W1: 25 and 45 degree lines from window at 26 Elm Road

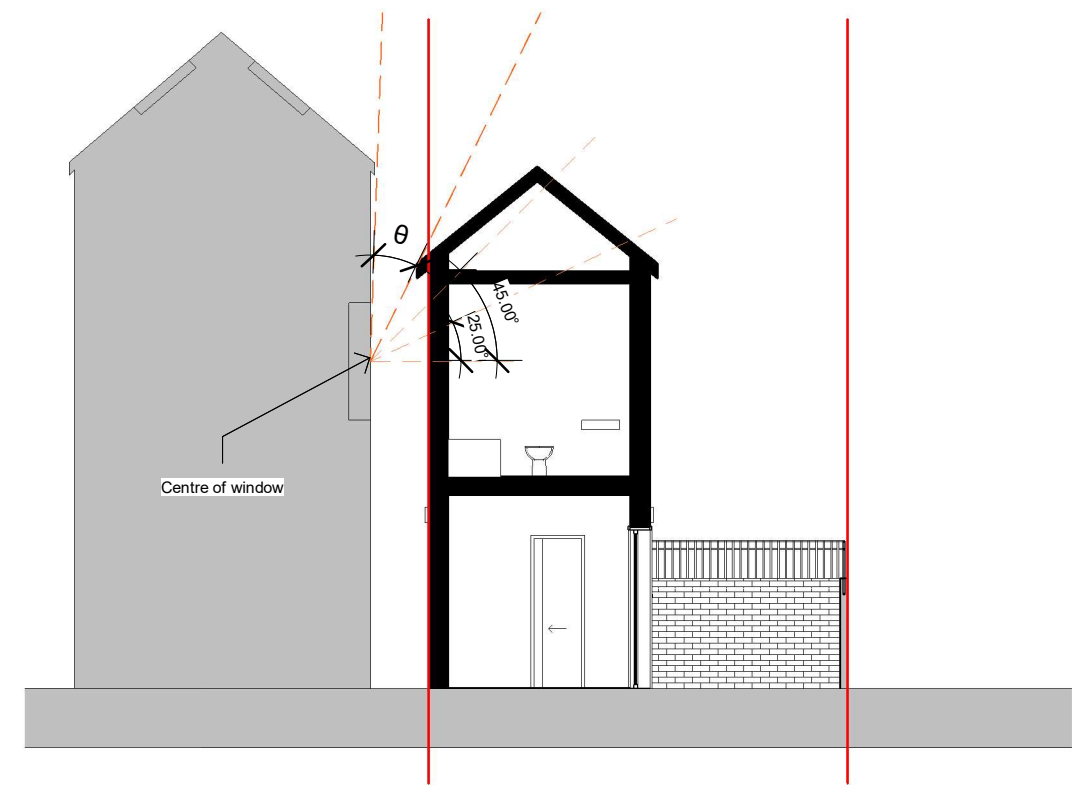
W1 Daylighting likely to be significantly affected- vertical sky component <27% for any main window and the proposal decreases the value by more than 0.8 times

W1 is facing staircase and thus not considered to have a major impact
